Dirk A. Danley, Jr., Principal Planner
Department of Community Development, Zoning Section
Lee County
P.O. Box 398
Fort Myers, FL 33902-0398
Email: DDanleyJr@leegov.com

RE: Response to the Lee County Department of Community Development's review comments dated July 26, 2022 regarding Case No.: DCI2022-00002

Daniels Parkway South
Mixed Use Planned Development
Schedule of Deviations

Enhanced Lake Management Plan

Figure 1
Existing and Proposed
Sandstone Aquifer Monitoring Wells
Lee County, Florida

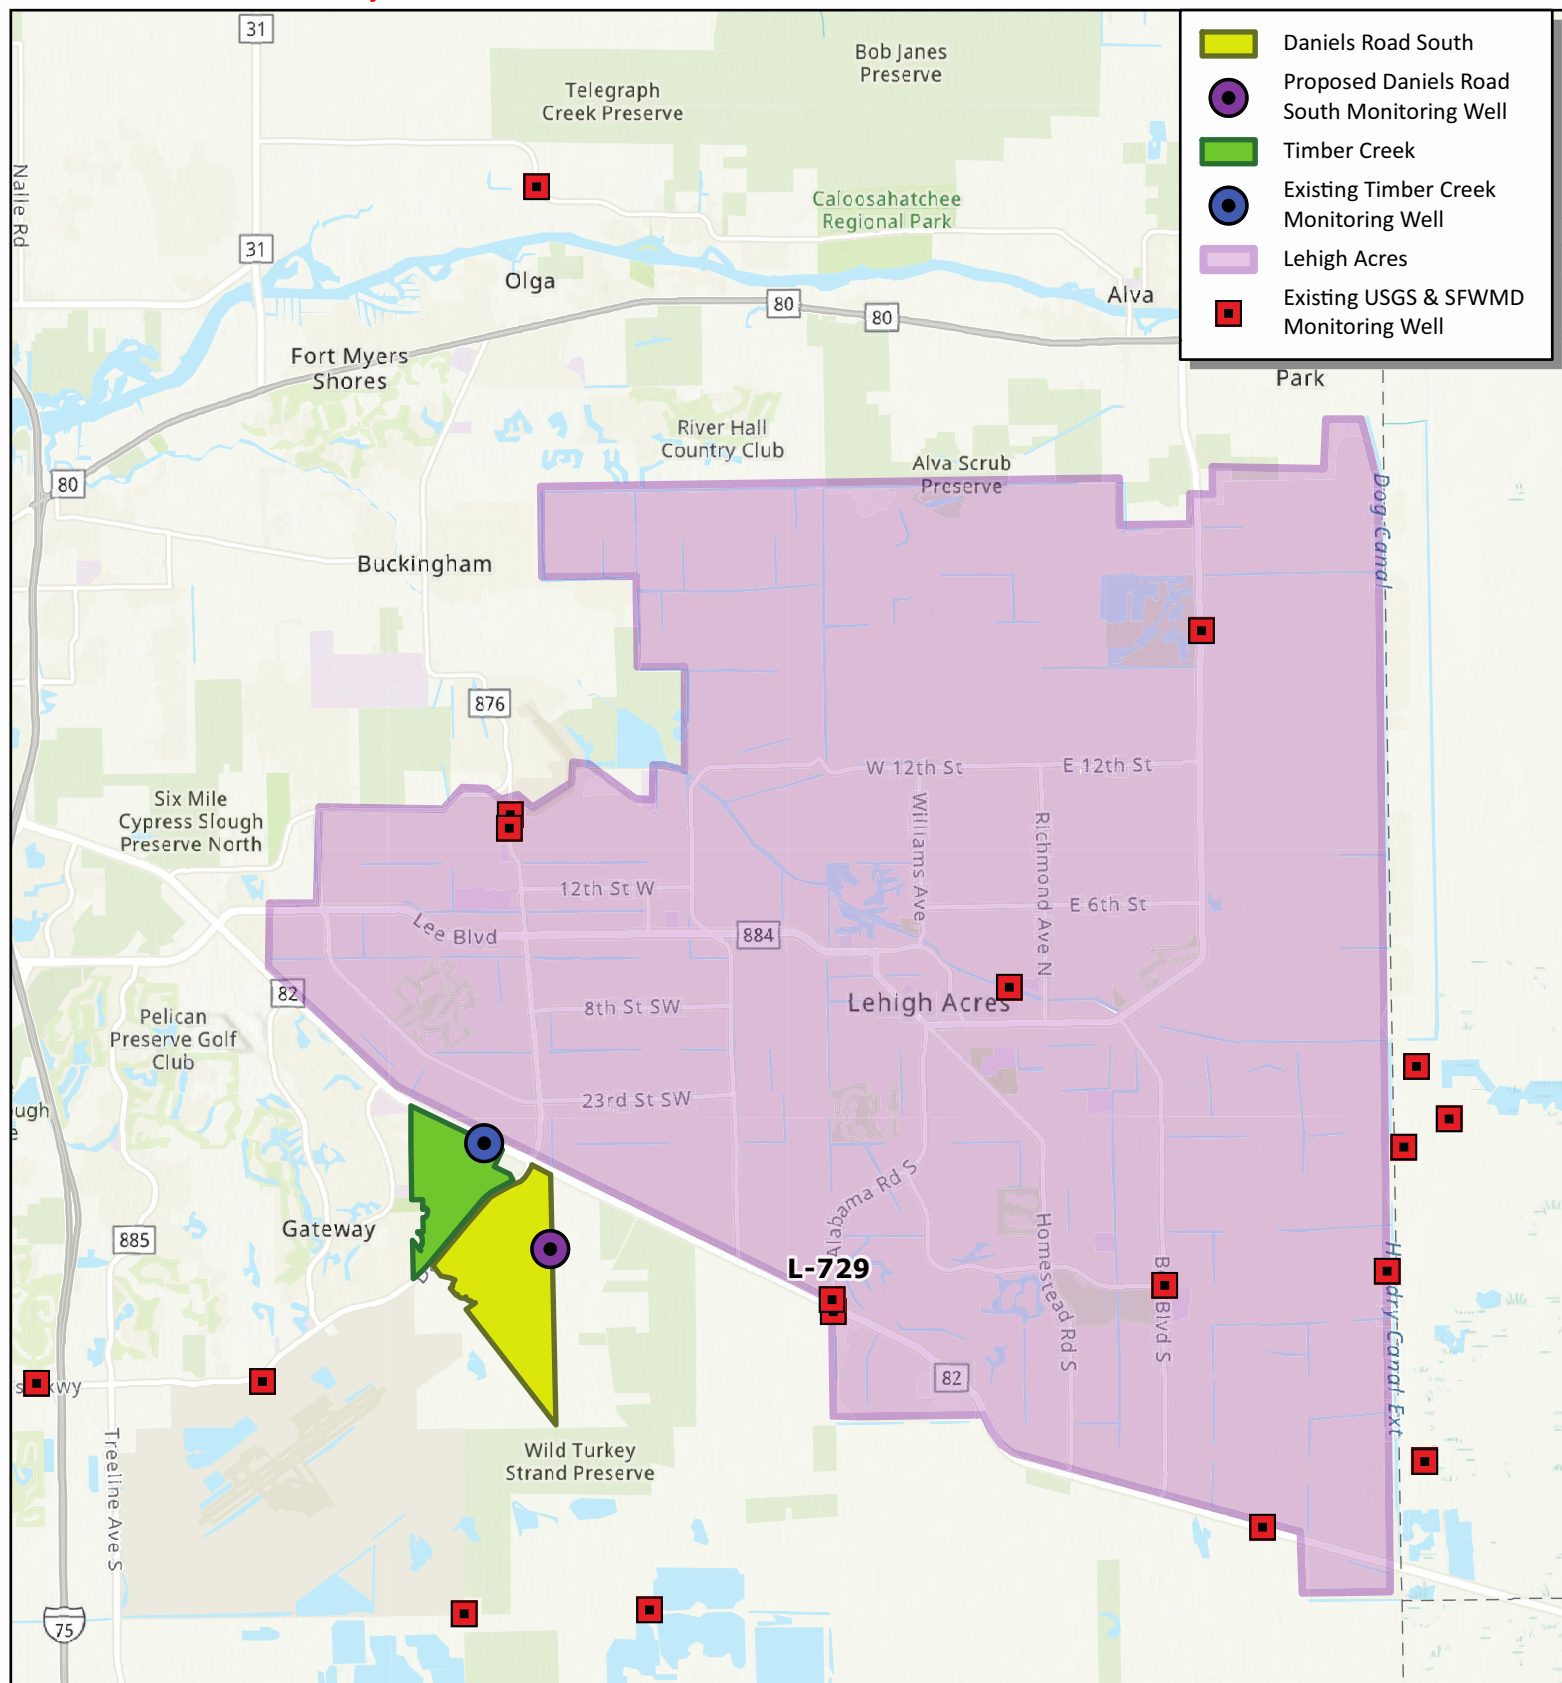
4. The ELMP does not include a section detailing the groundwater monitoring plan. Please prepare and include a groundwater monitoring plan in the ELMP. Monitoring wells shall be located on the North, East, and West borders of the project. The monitoring wells should be fitted with electronic water level measuring devices that at a minimum take measurements every 6 hours daily. Groundwater level data must be submitted to Lee County Quarterly.

5. Monitoring wells should be constructed prior to submittal of the Development Order to establish a baseline. Monitoring wells along the Northern and Eastern borders of the project are necessary to accurately depict any change, should it occur, to the Domestic Seld Supply wells on both borders.

RESPONSE: The ELMP has been updated to include groundwater level monitoring of the Sandstone Aquifer as requested. However, Staff's request to have the Applicant install and then monitor Sandstone Aquifer water levels on three sides (north, east, and west) of the development is not warranted. As shown on the attached Figure 1, there is already an extensive water level monitoring network operated and maintained by the South Florida Water Management District (SFWMD) and the USGS. This existing network, including the Sandstone Aquifer monitoring well at the Applicant's Timber Creek development to the west, along with the proposed monitoring well to be located at the eastern boundary of their Daniels South development, provide for unparalleled assessment and protection of groundwater resource conditions. Requiring additional monitoring wells, beyond the one proposed by the Applicant, is therefore not considered necessary.

PWR's groundwater flow modeling was used to locate the proposed Sandstone Aquifer monitoring well along the eastern property boundary and the Applicant's proposed water level monitoring will provide additional assurance that no adverse impacts will occur to the nearest existing legal users along Shawnee Road. In addition, the model predicted drawdown previously provided to Staff is approximately circular in shape and exhibits similar magnitudes of drawdown in all directions. This simplifies the monitoring approach and further negates the need for additional monitoring wells.

Staff's comment regarding monitoring along the northern and eastern borders of the project was addressed in the response to Question No. 4, above.

Figure 2
Daniels Road South
WBIDs and DR/GR
Lee County, Florida

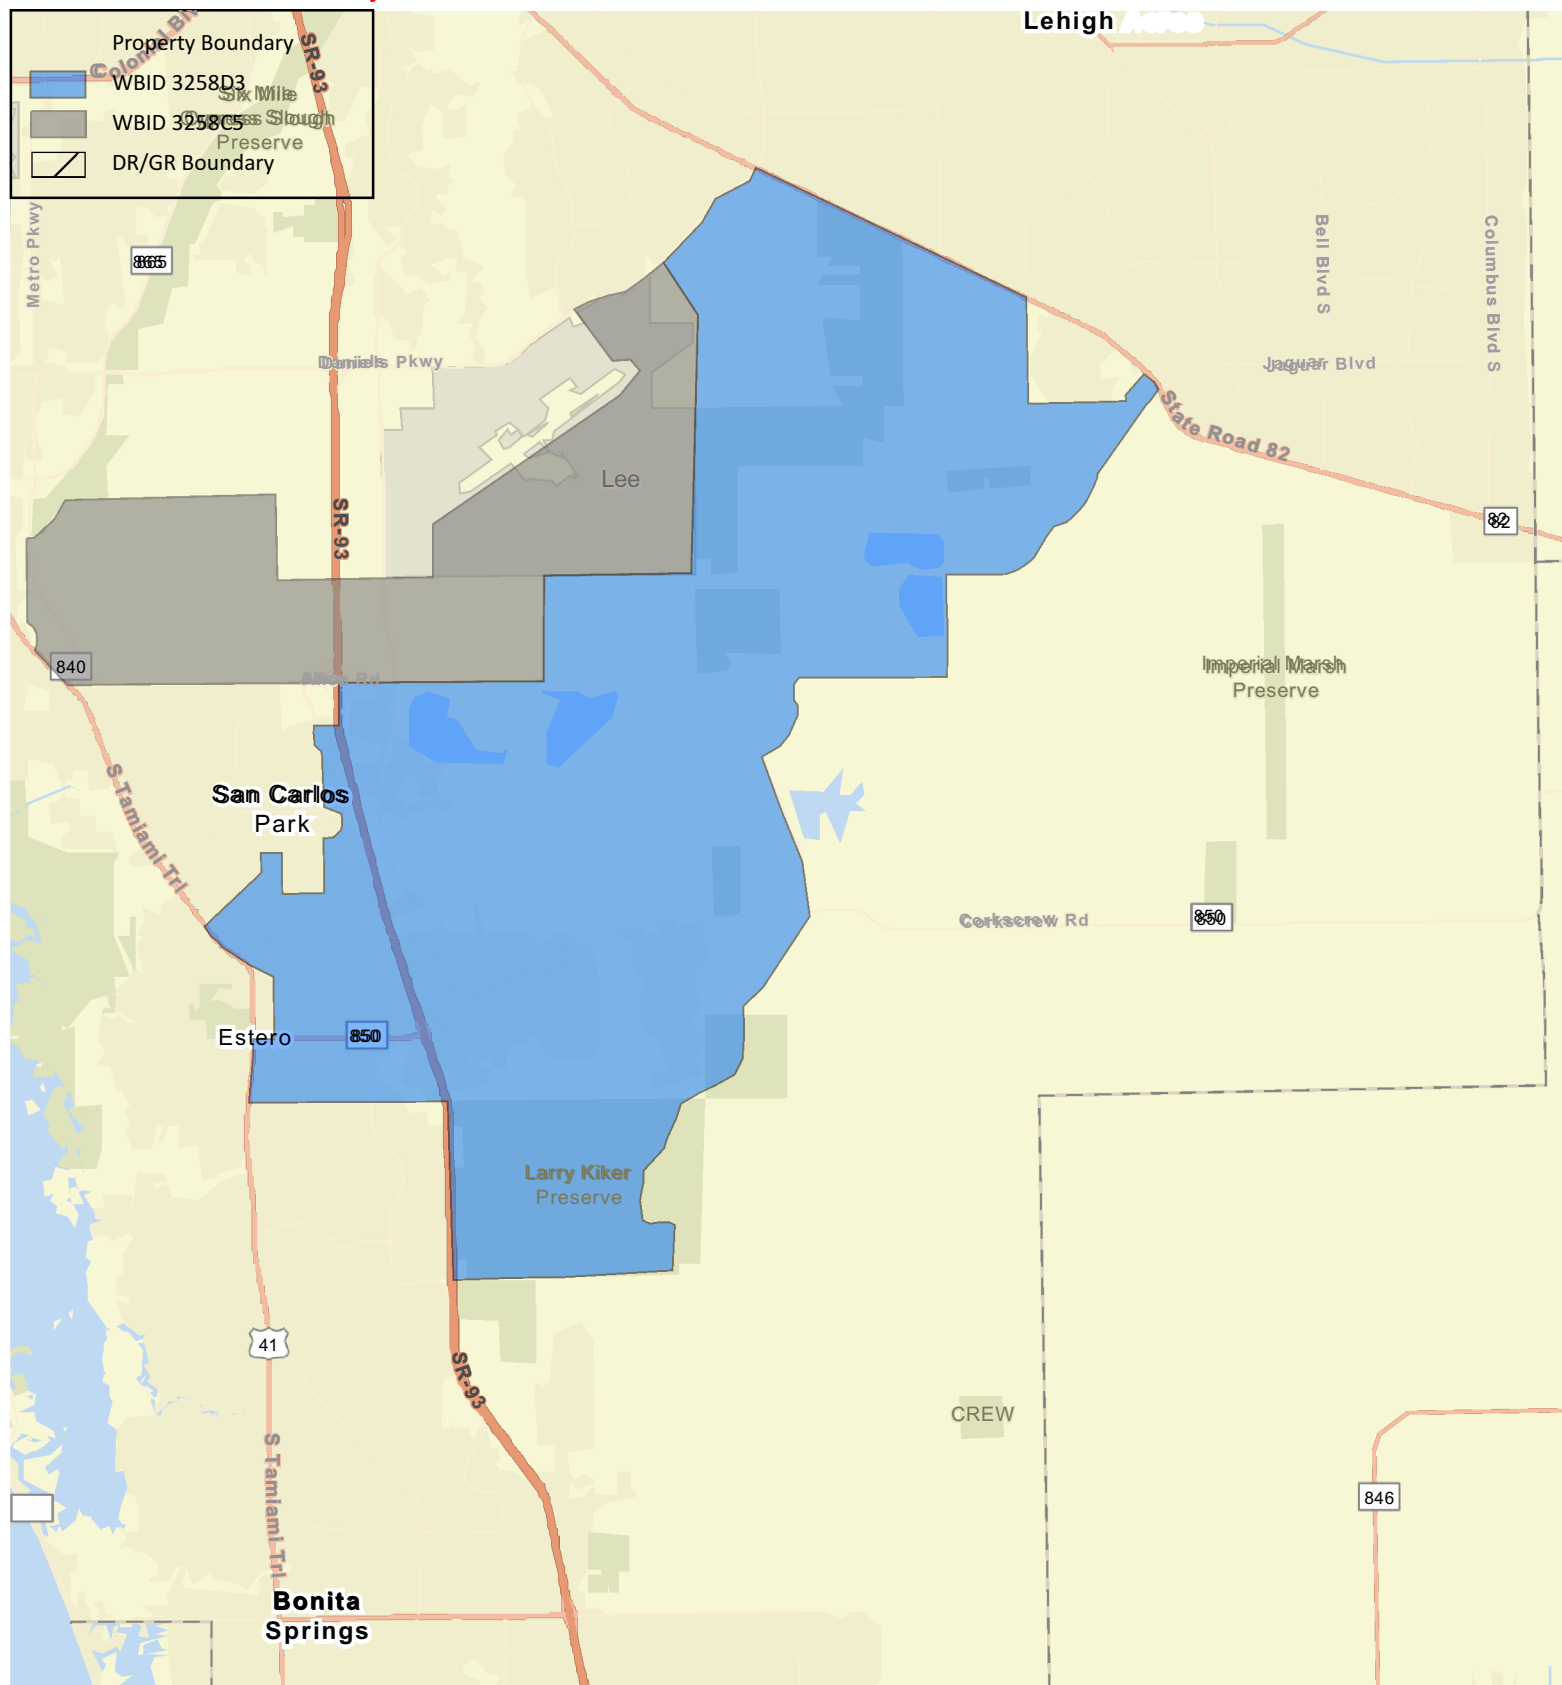
6. The subject property is proposing to utilize an integrated stormwater management system to serve both the proposed commercial uses abutting SR 82 and the proposed residential development. Stormwater from both parts of the development flow south, as seen in the Master Drainage Plan, and will outfall into Water Body Identification (WBID) No. 3258C5, which is impaired for Metals and on the FDEP Study List for Dissolved Oxygen. Please revise the ELMP to include sampling for Iron, Zinc, E. coli, and TSS.

RESPONSE: As shown on Figure 2, the Applicant's property occurs within WBID No. 3258D3, which is currently not impaired for any constituent, and extends to the southwest through a large proportion of the DR/GR. Therefore, Staff's assertion that since an adjacent WBID (3258C5) is impaired for a single naturally occurring element, Iron (taken from FDEP's Comprehensive Verified List dated Nov. 14, 2022) does not appear to justify the need for testing of additional constituents such as Zinc, E.coli and Total Suspended Solids (TSS). In addition, the Applicant has already proposed testing for nutrients, the most common surrogate for low Dissolved Oxygen levels.

However, in the interest of addressing Staff's comments, the Applicant has agreed to adding Iron, Zinc, E. Coli, and TSS to the two (2) proposed sampling locations on the western side of the project (SW-2 and SW-3).
